Date: 25.08.2020

Department: SAV

D-Lite RX ONE & 4 fan (Error E8)

Technical problem

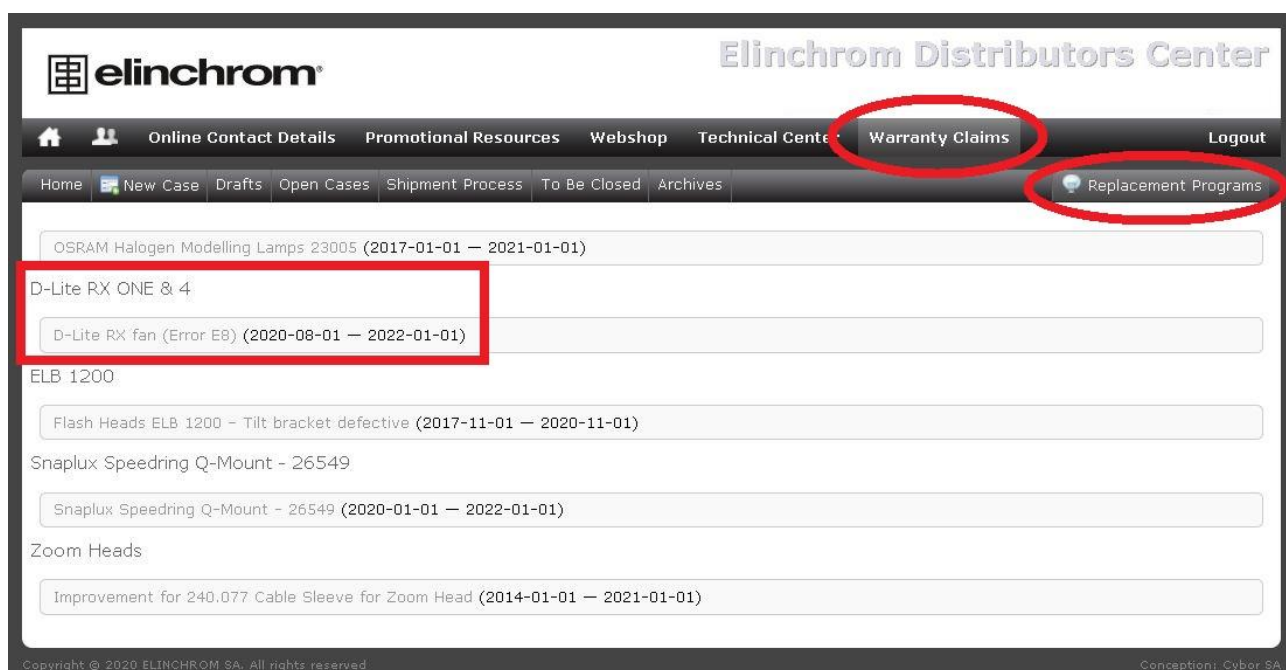
The fan (226.105) for D-Lite RX ONE & 4 units with the serial number "7" in the 3rd position (ex: S2072048701234) and bought before 25 August 2020 could be defective on some units and needs to be repaired by replacing the fan 226.105.

Due to insufficient air flow of the fan, the unit may overheat. In this case the unit will show error E8.

Use the "Replacement Program" of the D-Lite RX ONE & 4 available in our Distributors Center > Warranty Claims > Replacement Programms to obtain the requested quantity of fan 226.105 you need.
